TECHNICAL SERVICE BULLETIN			
DATE ISSUED	MODEL YEAR(S) AFFECTED	MODEL(S) AFFECTED	TSB #
2/24/99	1998-1999	ALL	171
BRAND		TYPE	
All <input checked="" type="checkbox"/> American Star <input type="checkbox"/> Kountry Star <input type="checkbox"/> Dutch Star <input type="checkbox"/>		All <input checked="" type="checkbox"/> T T <input type="checkbox"/> F W <input type="checkbox"/>	
NewAire <input type="checkbox"/> Mountain Aire <input type="checkbox"/> Kountry Aire <input type="checkbox"/> London Aire <input type="checkbox"/>		C A <input type="checkbox"/> D P <input type="checkbox"/> D B <input type="checkbox"/>	
<input type="checkbox"/> Air Conditioning & Heating			
<input type="checkbox"/> Electrical Components			
<input type="checkbox"/> Appliances & Accessories			
<input type="checkbox"/> Exterior Components			
<input type="checkbox"/> Cabinets & Furniture			
<input type="checkbox"/> Interior Components

Bulletin Number : 1002
Effective Date: August 1, 1998

Traveler® Toilet Odor

Traveler® Toilets Elimination of Overflow Holes

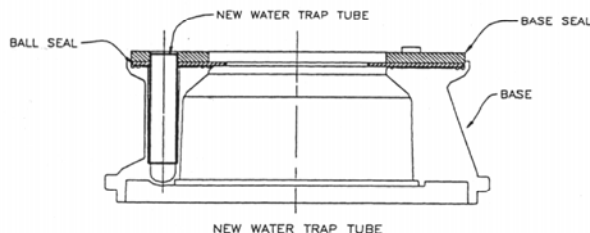
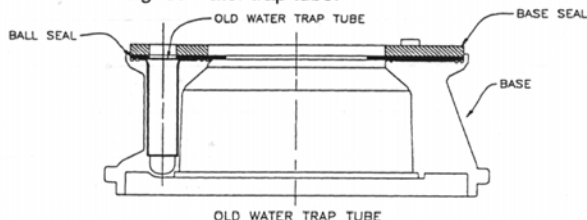
Symptom: Odor comes out of the overflow holes in the toilet bowl when the RV is in a forward motion.

Cause: On some toilet installations, the toilet bowl may have been rotated to compensate for a misaligned floor flange. If the bowl was not separated from the base when rotated, the seals may have rotated with the bowl causing the seals to be out of alignment with the water trap tube. This misalignment could create a path for odor to travel from the holding tank through the overflow holes.

To eliminate this problem from occurring in the future, SeaLand Technology has redesigned the water trap tube to index the seals in the correct position. The tube previously fit below the seals and now extends up into them. The tube helps prevent the seals from being moved out of position if the bowl is not separated from the base before rotating. Figures below illustrate the old water trap tube and the new redesigned water trap tube.

Corrective Action: If odor is present, remove the bowl from the base and realign the seal hole with the base hole.
